UNITED STATES PATENT AND TRADEMARK OFFICE

| APPLICATION NO. | FILING DATE | FIRST NAMED INVENTOR | ATTORNEY DOCKET NO. | CONFIRMATION NO. |
|---|-------------|----------------------|--------------------------------|------------------|
| 10/796,811 | 03/09/2004 | Barry T. Brinks | 502724 | 2081 |

Office Action Summary

DETAILED ACTION

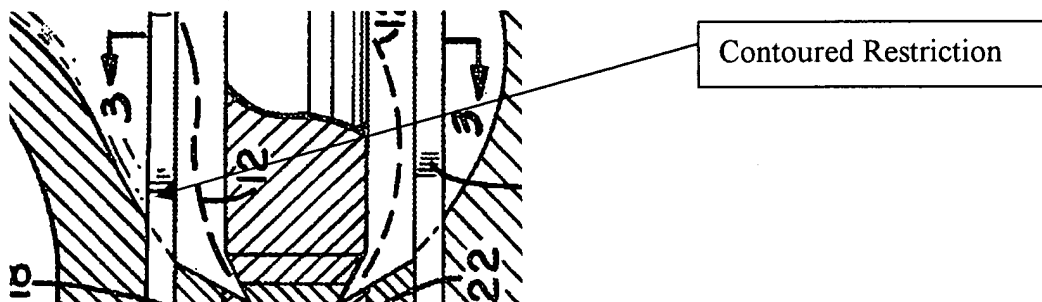
2. Applicants' arguments filed 10/13/2005 have been fully considered but they are not persuasive. Applicants' argue that claims 10, 28, and 39 are now in compliance with 35 U.S.C. 112, second paragraph, the examiner disagrees. It is still unclear to the examiner how a flow path can pass through an outlet flange but be as far away as possible from that flange as well as making the flow path eccentric results in the flow path being as far away as possible.

Applicants' also argue that the "step" of Platt is not a "nozzle throat", the examiner disagrees. When performing a structural comparison of Applicants' claimed invention and Platt, the "stepped portion" of Platt anticipates the "nozzle throat" of Applicants' claimed invention.

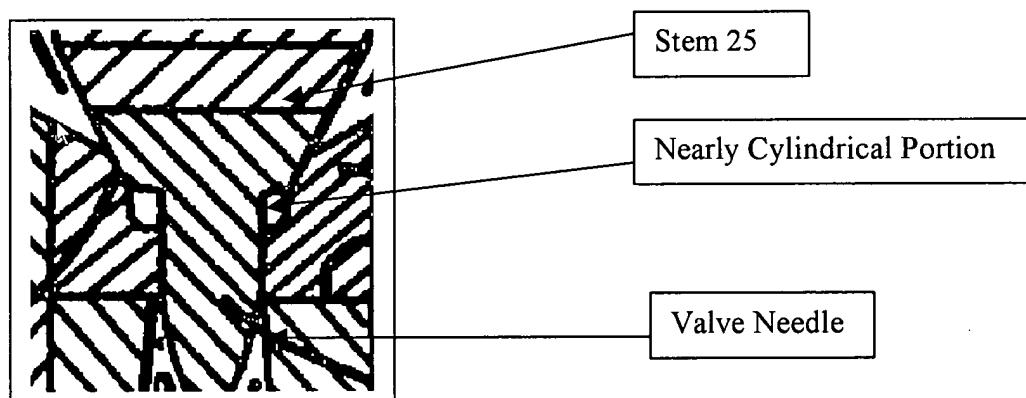
Applicants' also argue that Platt does not disclose a curved contoured portion upstream of the nozzle, the examiner disagrees. The following figure was extracted from figure 1 of Platt and clearly shows a contoured restriction upstream of the nozzle in the nozzle area:

Applicants' further argue that Platt does not anticipate claim 17 because the examiner did not point out that the "nearly cylindrical portion" of the valve needle is "upstream of an axial location where the valve needle begins to taper" the examiner disagrees. The examiner simply pointed out the corresponding structure that is recited within Applicants' claims. Clearly one looking at Platt could ascertain that the nearly cylindrical portion of Platt is upstream of the tapered portion of the valve needle. Platt does disclose a valve needle having a nearly cylindrical portion upstream of an axial location where the valve needle begins to taper as seen in the following figure extracted from figure 1 of Platt:
